# CITY OF NAPOLEON DEPARTMENT OF BUILDING & ZONING APPLICATION FOR CERTIFICATE OF OCCUPANCY

### PERMIT

Plan review for James Shadle - Lot 39 - Appian Avenue

INSPECTION RECORD

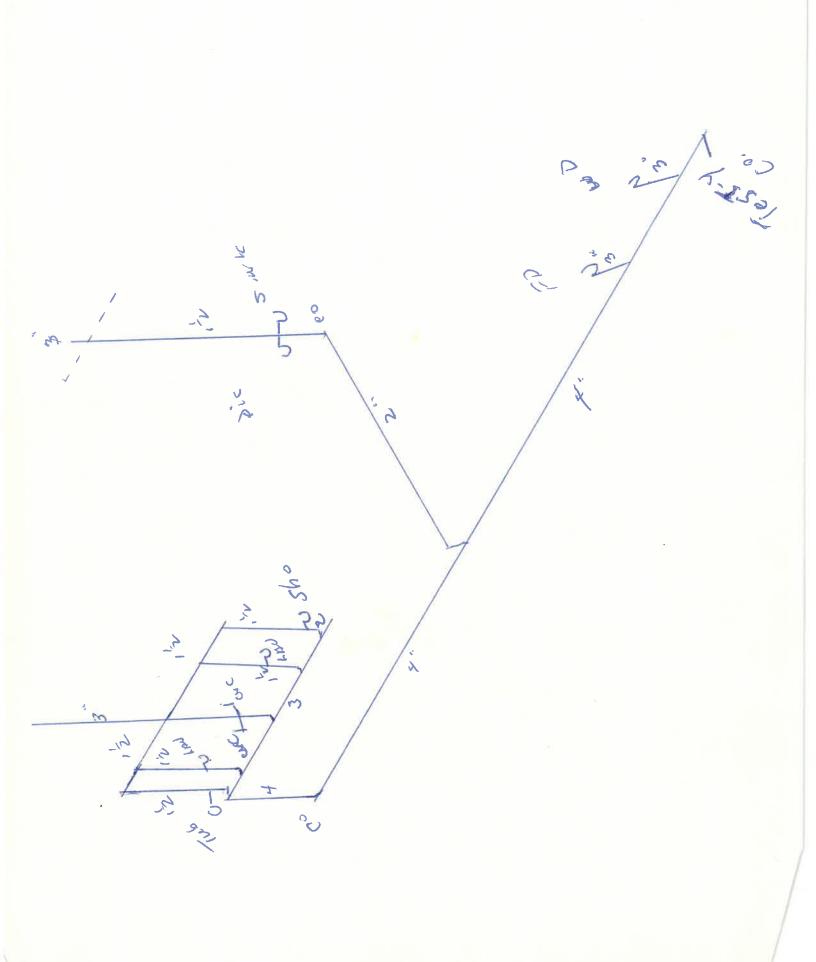
2. STOPPBR PUTON CLOST RODINCLOSET BY CIRCUIT PANIEL

1. GFCI BATH-GARBER
RYTTERIOR

3. FURNICE DOOR SOLID CORE
